STORE PROPERTY INVESTMENTS LTD
LAND WEST OF BROOK LANE AND
SOUTH OF A259
RUSTINGTON

ROAD SAFETY AUDIT RESPONSE
REPORT
STAGE 1 - ROAD SAFETY AUDIT

JUNE 2018

Project Code:	SPRust(BrookLane).1.
Prepared by:	OAN
Approved by:	VL
Issue Date:	June 2018
Status:	Final

drawing number
SPRUST(BROOK LANE).1/11

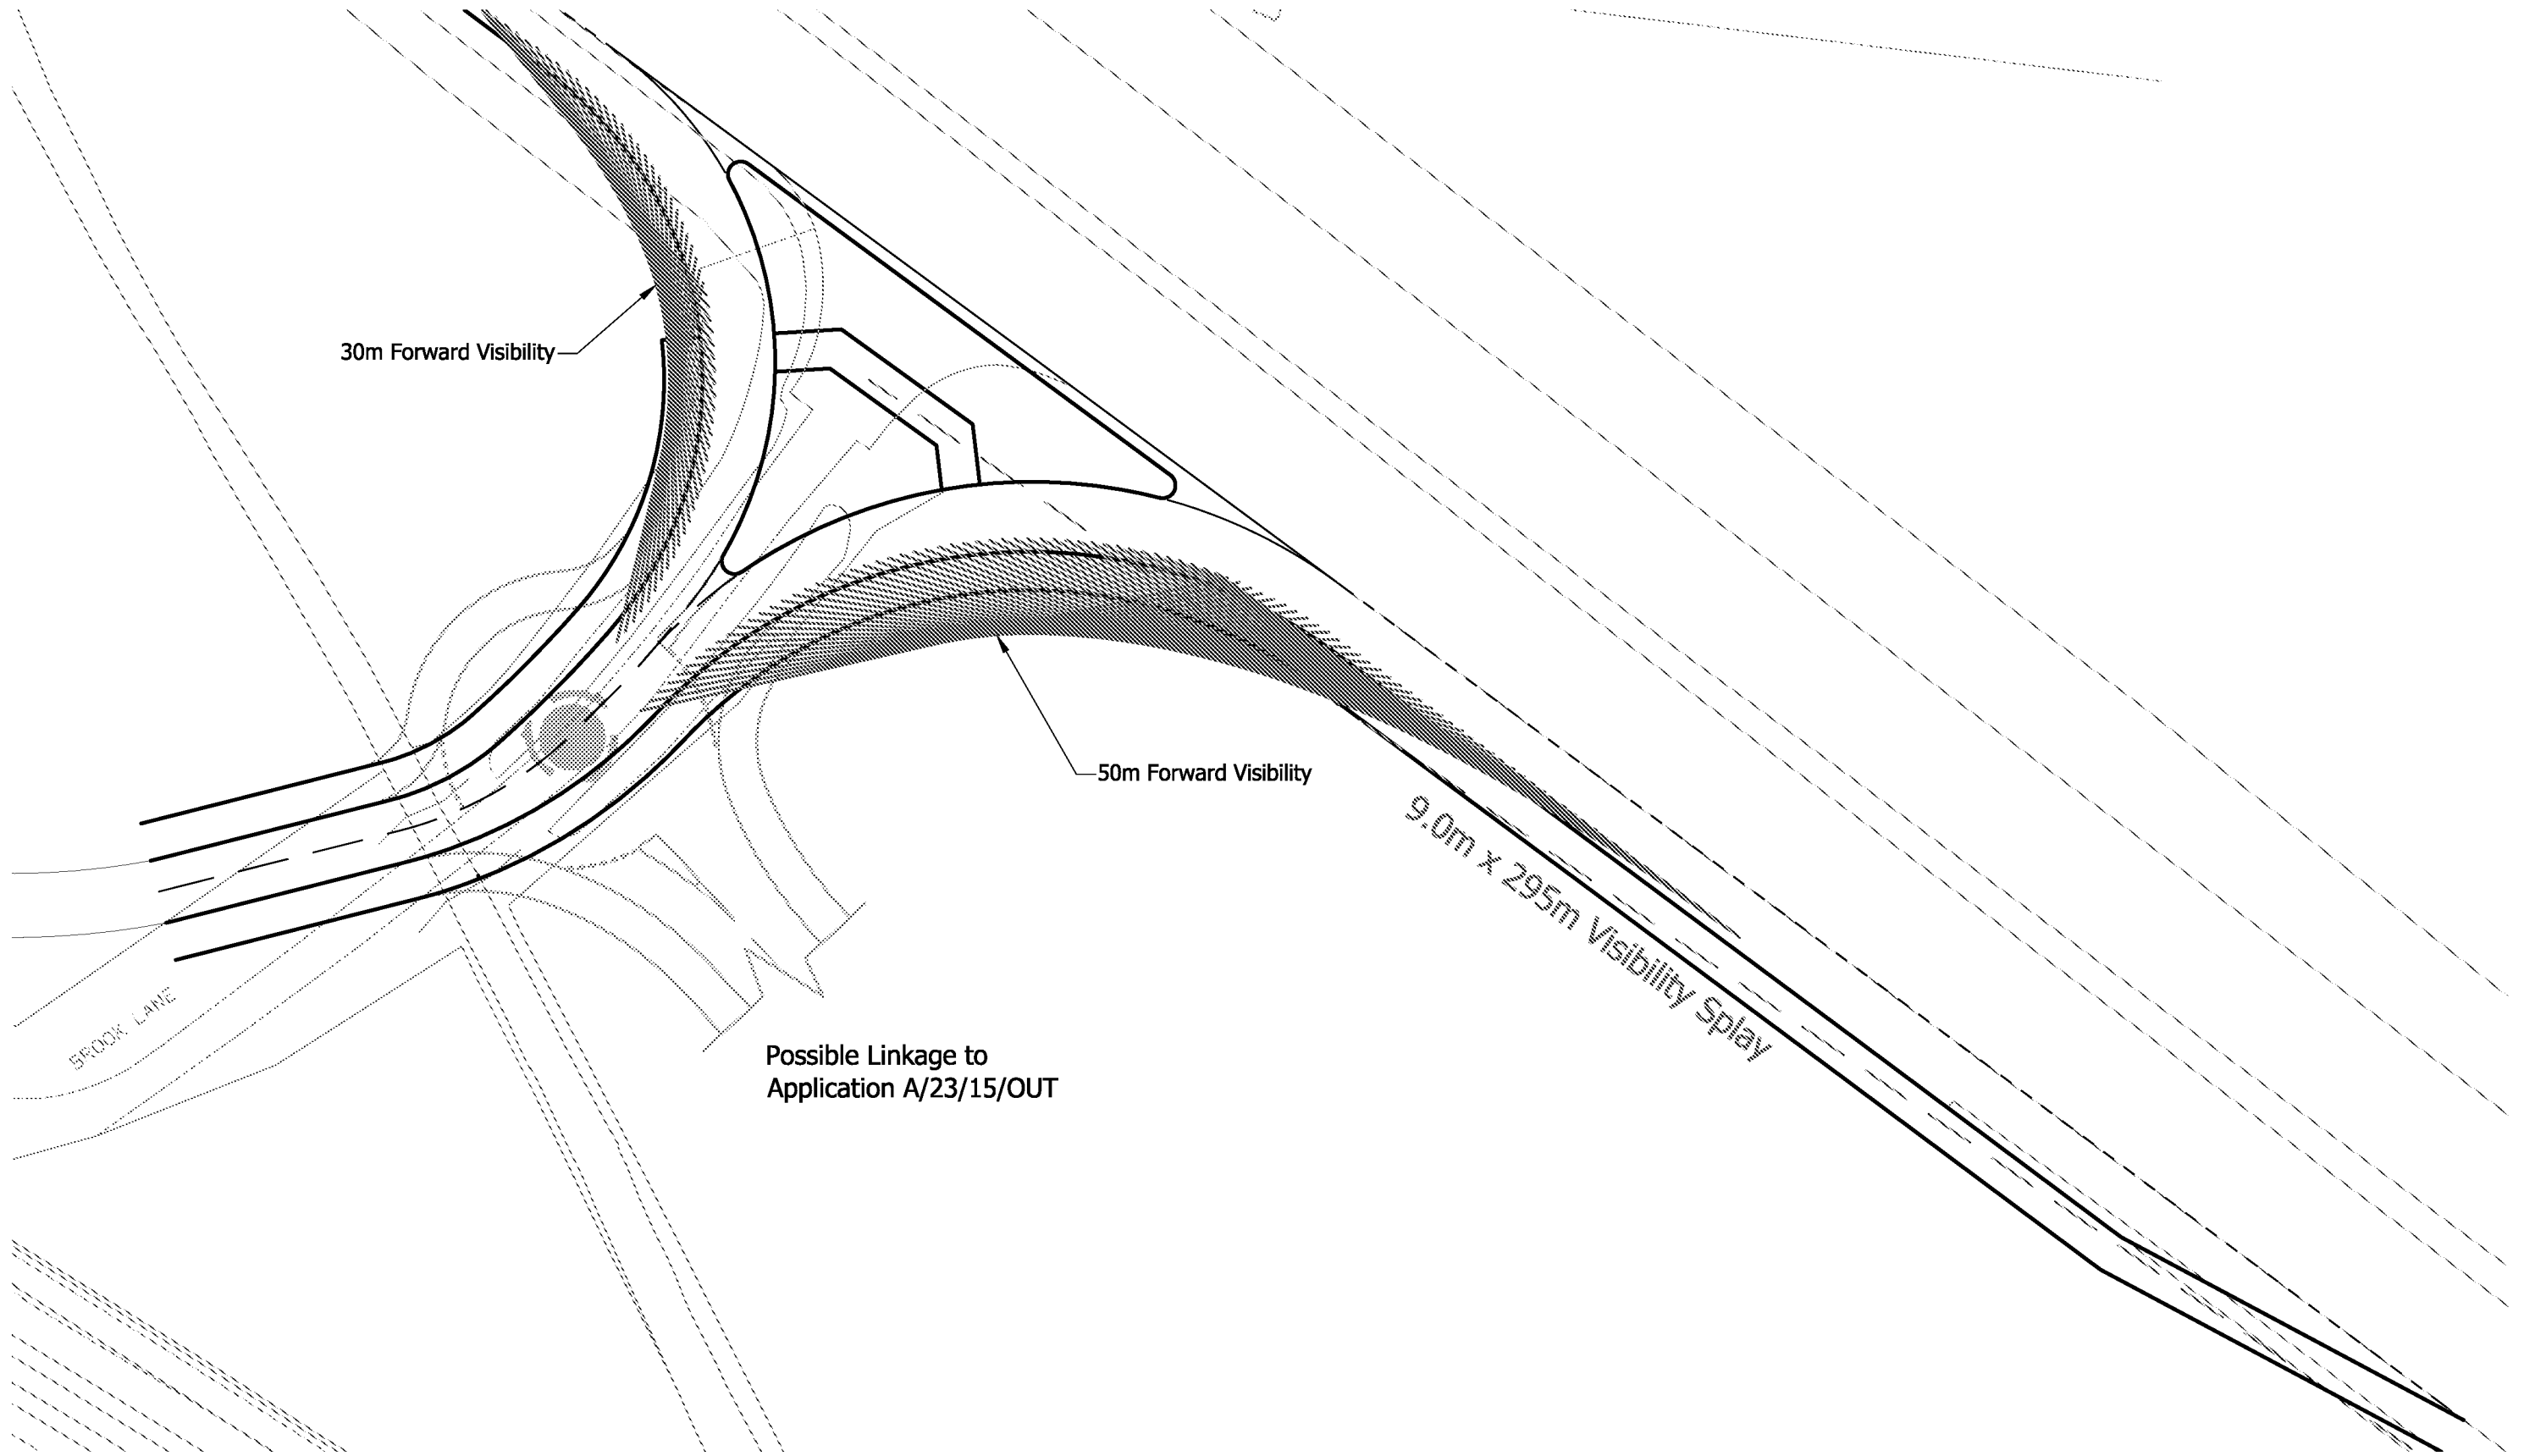
Summary: Visibility splays

Visibility splays have not been formally identified on the drawings submitted at this stage. It will be important that adequate splays are provided, this should include junction, pedestrian inter-visibility and forward visibility splays.

It was noted during the site inspection that junction and forward visibility splays could be obstructed by existing vegetation.

Provide visibility splays in accordance with relevant design standards and ensure that the splays will be kept free from obstruction. Any vegetation within the splays should be maintained to ensure that it does not extend beyond a vertical height of 0.6m. It will also be important that appropriate visibility is provided to all pedestrian crossing landing points.

This is agreed, visibility splays in accordance with West Sussex County Council approved requirements are shown on drawing SPRUST(BROOKLANE).1/11 included at **Appendix C**.

scale	1:500@A3	drawn by	OAN	checked by	VL
date	JUNE 2018	cad file	TK07.DWG		
drawing number	SPRUST(BROOK LANE).1/TK07				rev.

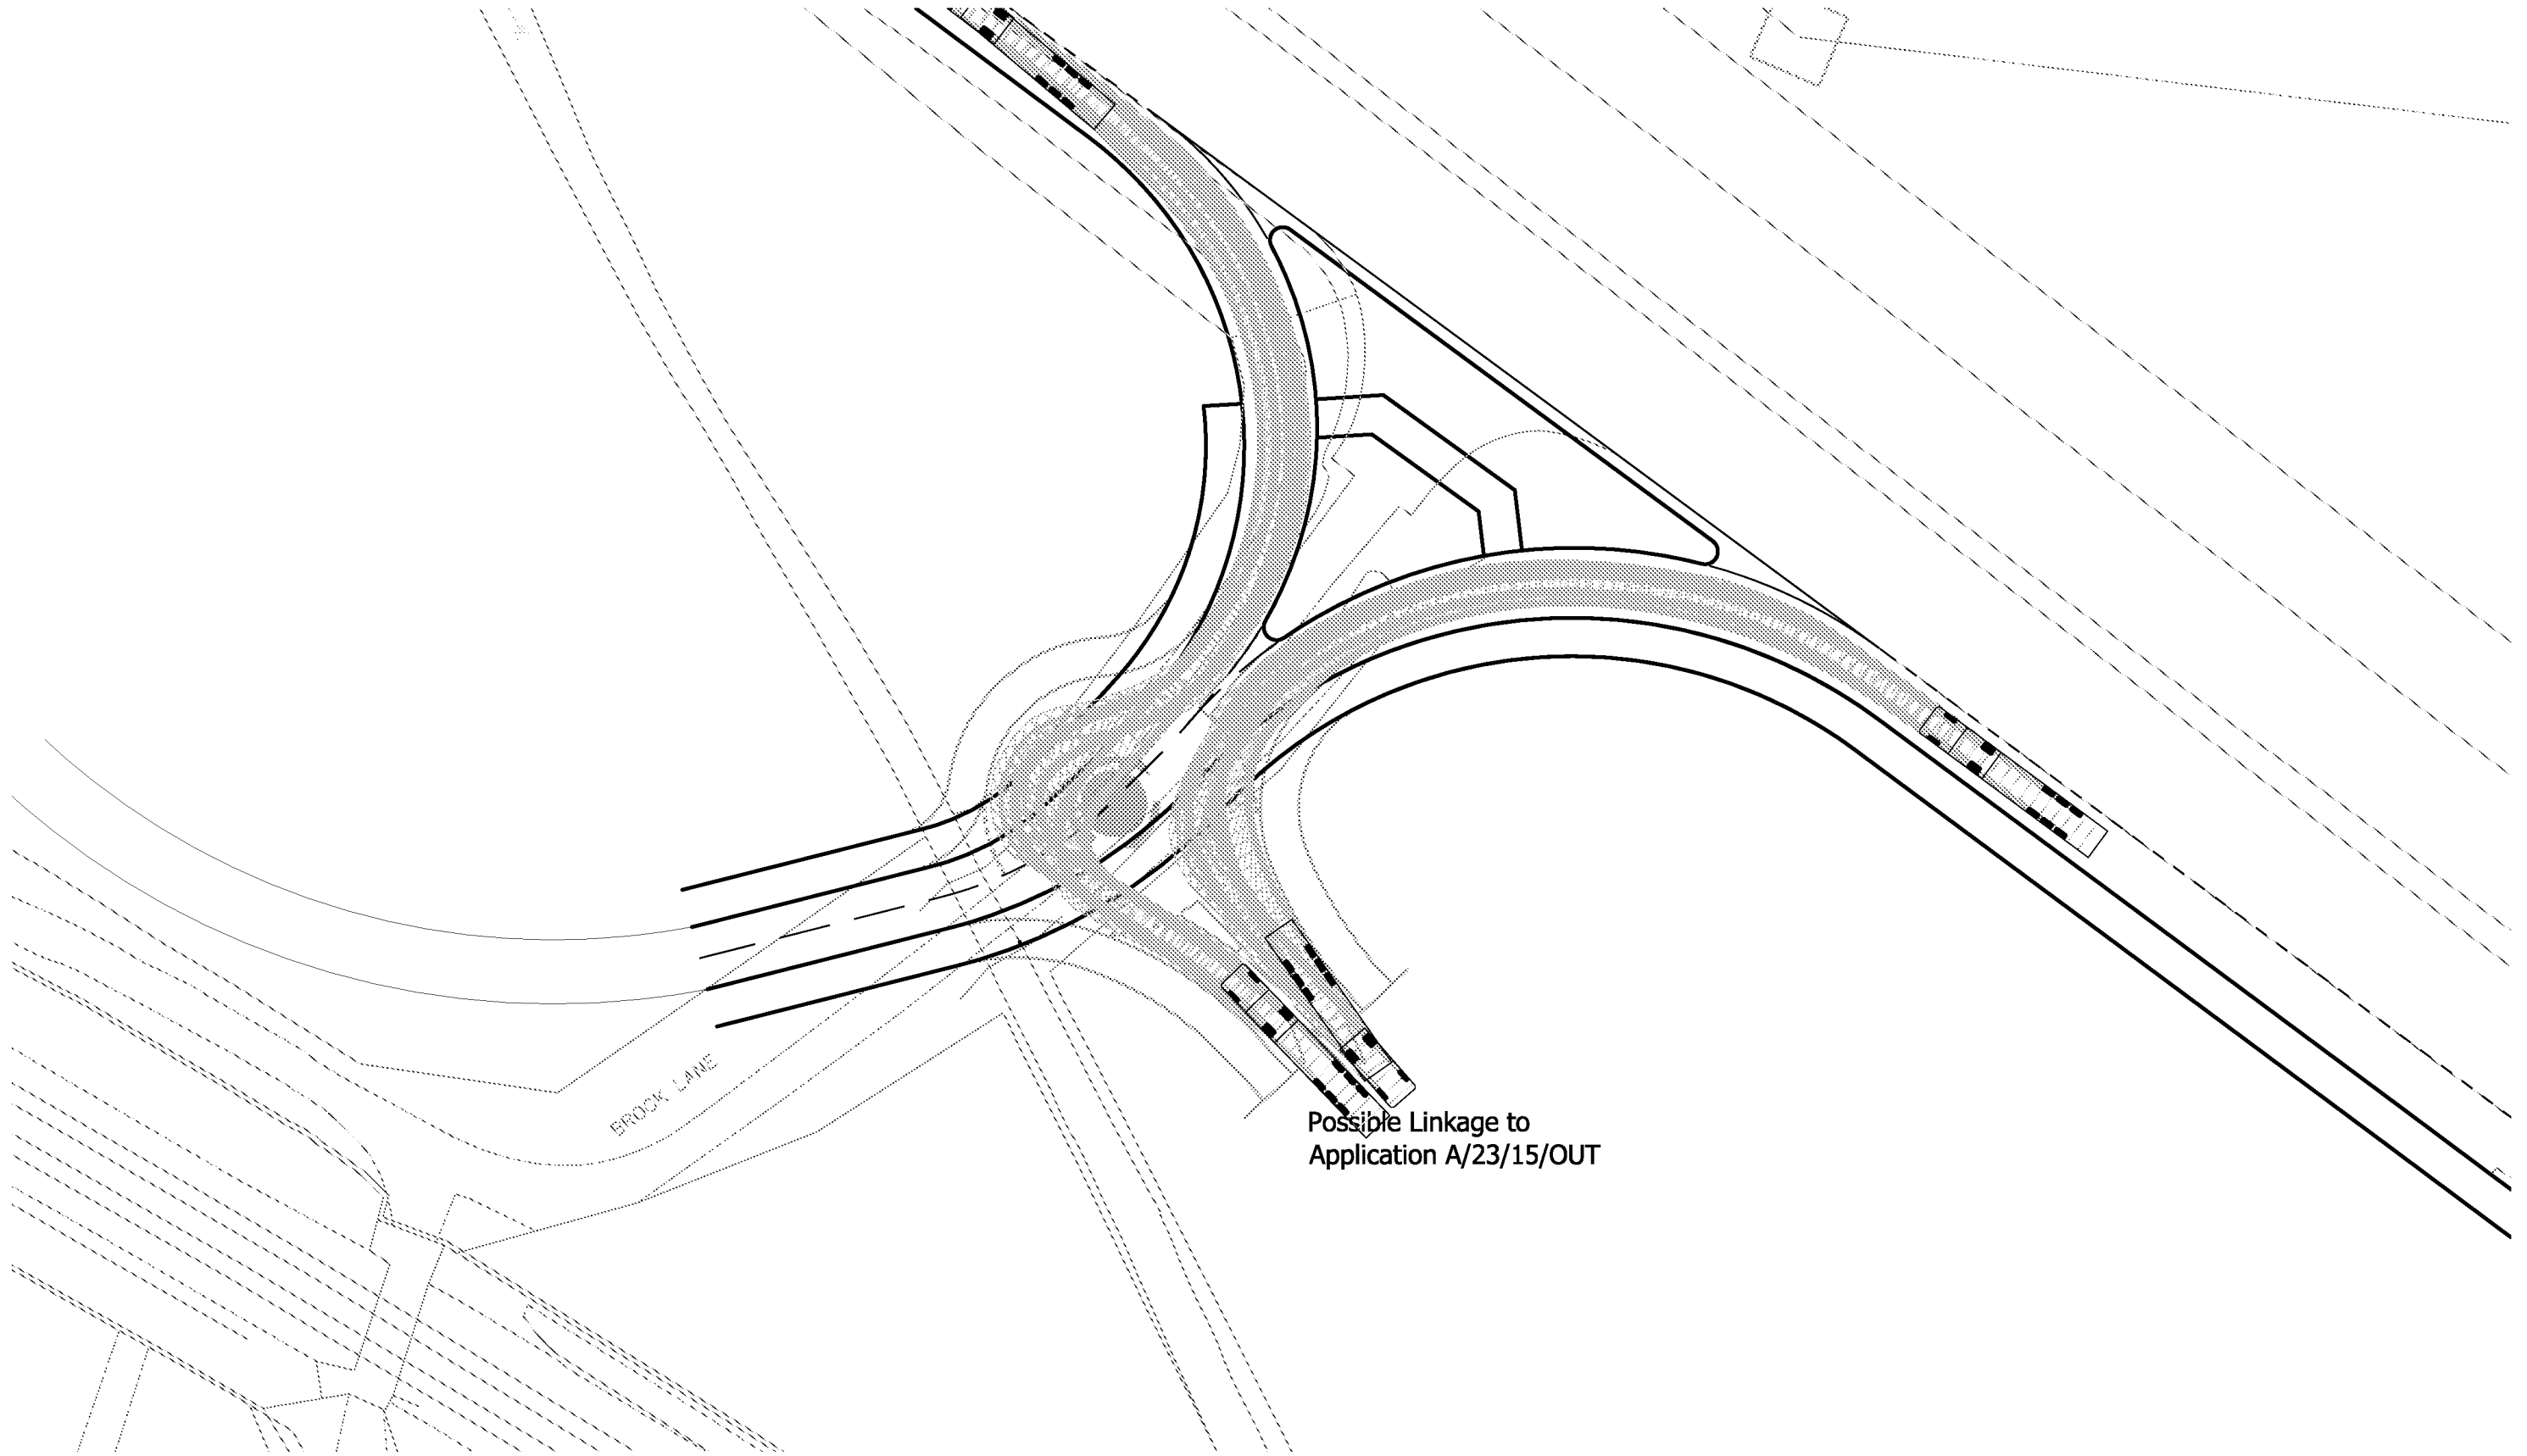
Summary: Servicing Arrangements

Details of swept paths have not been provided. It is important that all anticipated vehicles can access the site appropriately without traversing the footway or requiring excessive reversing manoeuvres.

Undertake swept path analysis using anticipated vehicles to ensure that the vehicles can access the site appropriately.

This is agreed, swept path plots of both a single deck bus and a 16.5m articulated vehicle are included at **Appendix C**. The swept path plots demonstrate that both vehicles can enter and exit the roundabout from all directions.
